SUBDIVISION REVIEW SHEET**CASE NO.:** C8-2021-0078**COMMISSION DATE:** December 7, 2021**SUBDIVISION NAME:** Cearley preliminary plan**ADDRESS:** 1601 Cedar Bend Drive**APPLICANT:** Cearley Tract Development, Inc. (Garrett Martin)**AGENT:** Atwell, LLC (Connor Overby, P.E.)**ZONING:** SF-4A-CO**NEIGHBORHOOD PLAN:** none**AREA:** 0.703 acre (30,642 sf)**LOTS:** 123**COUNTY:** Travis**DISTRICT:** 7**WATERSHED:** Walnut Creek**JURISDICTION:** Full Purpose**SIDEWALKS:** Sidewalks will be constructed along all interior streets.**DEPARTMENT COMMENTS:**

The request is for the approval the Cearley preliminary plan, consisting of 123 single-family lots on 29.17 acres.

CITY OF AUSTIN –DEVELOPMENT SERVICES DEPARTMENT
SUBDIVISION APPLICATION – MASTER COMMENT REPORT

PROJECT NAME: Cearley Community Subdivision Preliminary Plan
LOCATION: 1601 CEDAR BEND DR

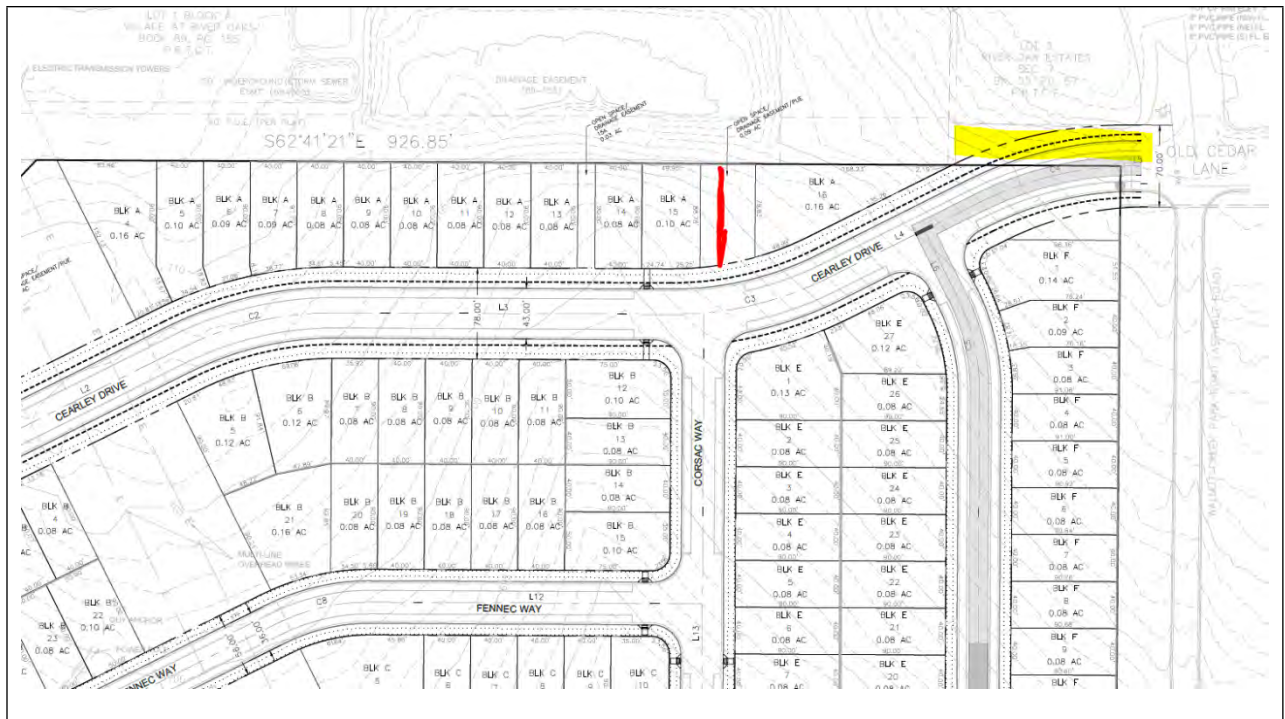
FYI. Safe Routes To School (SRTS) from Public Works Department had the following comments. Please coordinate with Tracy Ho (Email: Tracy.ho@austintexas.gov , Ph: 512-974-7142) for further details.

- The area highlighted yellow overlaps SRTS proposed trail entrance (see snapshot below). SRTS would like to discuss this area with our trail designer and ATWELL consultant to iron out the details.
- A 12ft concrete walkway within the PUE between lot 15 & 16 BLK A (U0 plan) to connect to the trail on Pflugerville ISD property (see snapshot below – redline).
